BLOOMINGTON PLAN COMMISSION STAFF REPORT Location: 650 W. Guy Avenue

CASE #: DP-34-21 DATE: November 15, 2021

REQUEST: The petitioner is requesting secondary plat approval for a subdivision of 5.34 acres for 30 residential lots and 3 common area lots in a Planned Unit Development zoning district.

Date:	November 15, 2021
То:	Bloomington Plan Commission
From:	Bloomington Environmental Commission
Subject:	DP-34-21: Osage Place Preliminary Plant 650 Guy Avenue

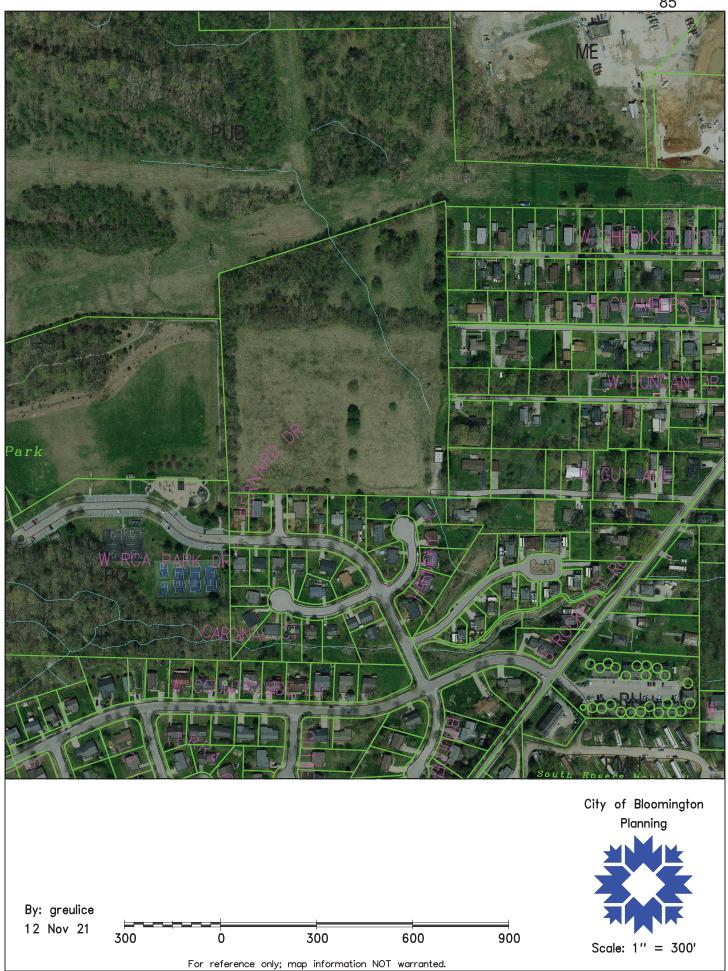
1.) There is signage required around the perimeter of easements per UDO 20.05.04, Easements. To make the number and locations clear from the beginning, the EC recommends that the location of all signs be shown on the Plat.

2.) The draft plat does not clearly depict that the Conservation Easements (CE) are also Common Areas. The EC believes that all of the dedicated CE areas should be in a common areas and not on private property.

- 1.) Show the locations of signage associated with the easements.
- 2.) Show on the plat that all Conservation Easements are in common areas and not on private property.
